DRAFT
ENGINEERING EVALUATION / COST ANALYSIS
BENNINGTON MUNICIPAL LANDFILL SUPERFUND SITE
BENNINGTON, VERMONT

APRIL 15, 1994
REV 1 JUNE 25, 1994

**FIGURE 3-1
Preliminary Removal Action Schedule
EE/CA - Bennington Superfund Site**

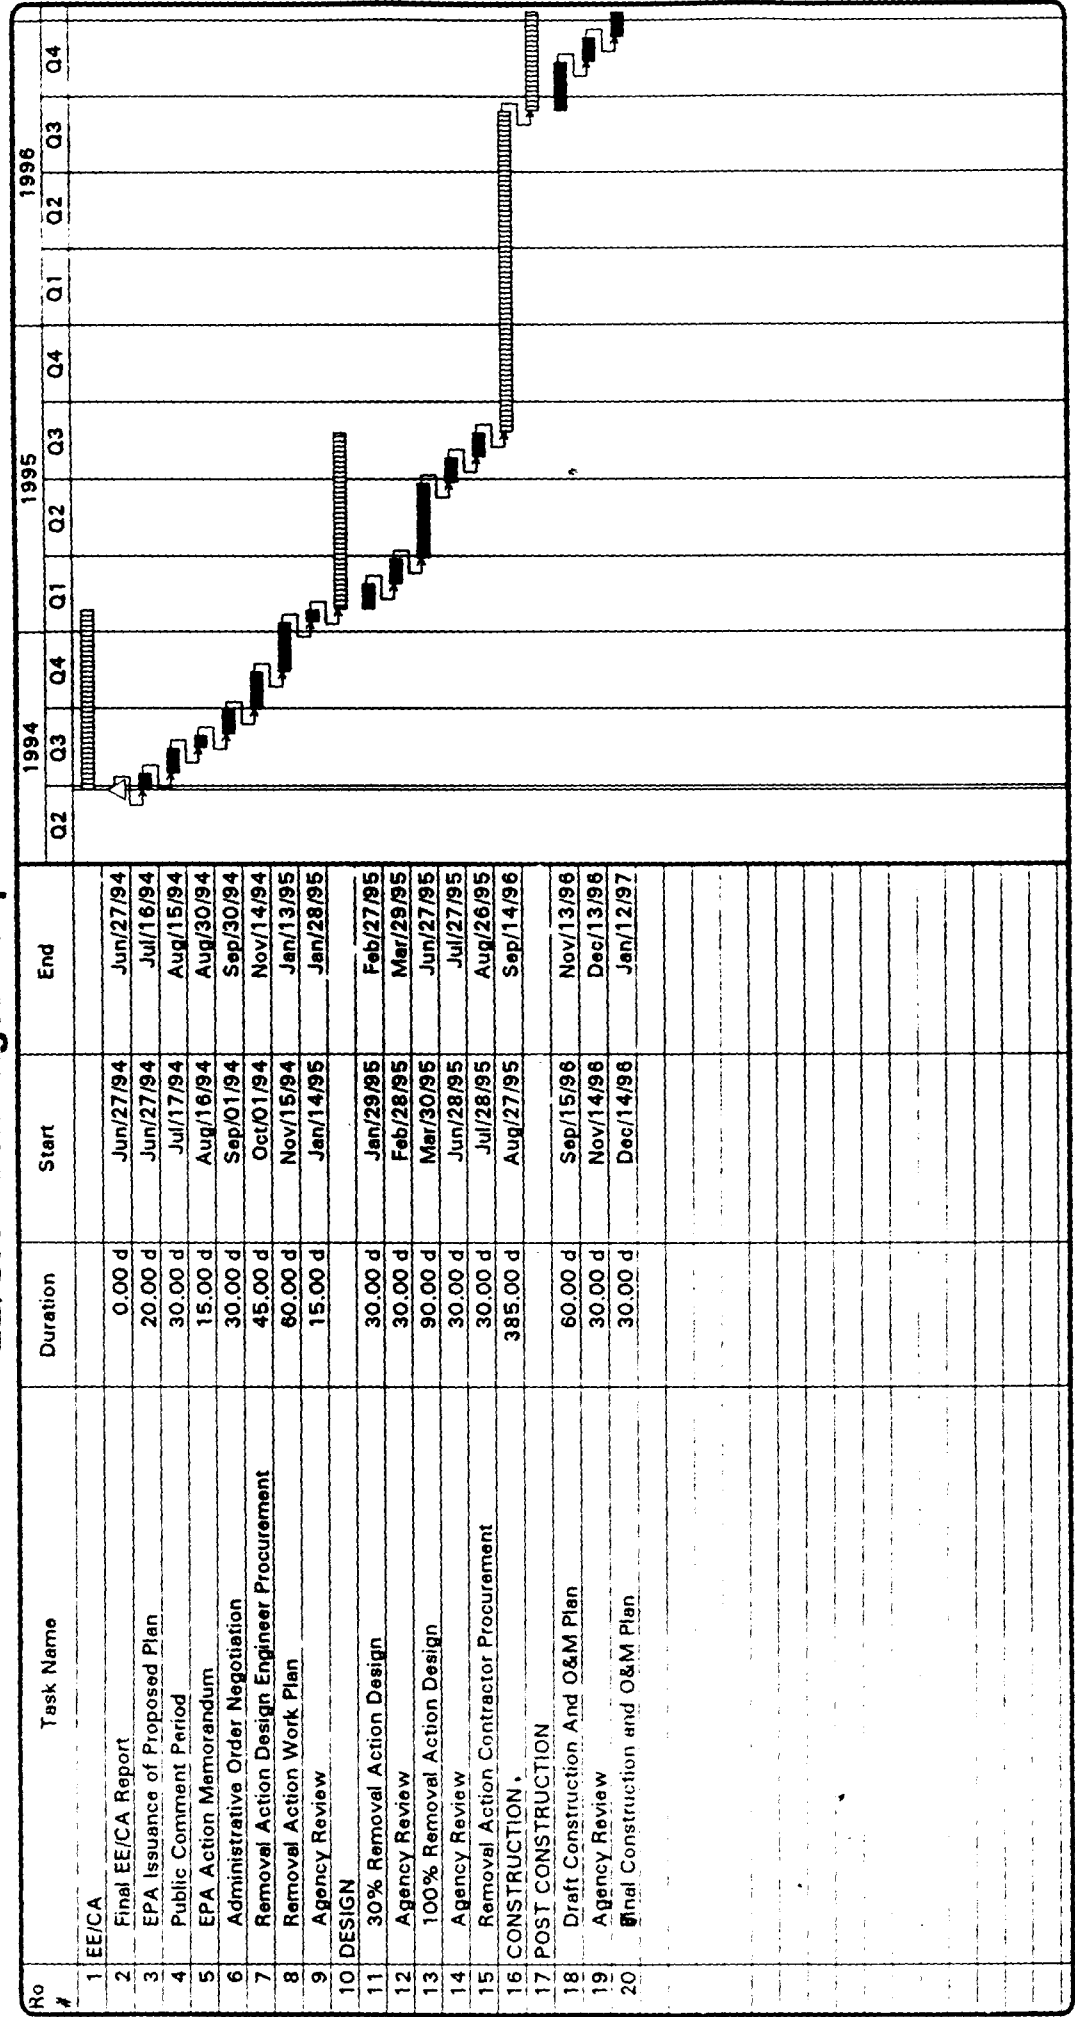
34. Fig. 3-1 -- Redo the dates to match the planned EE/CA schedule.
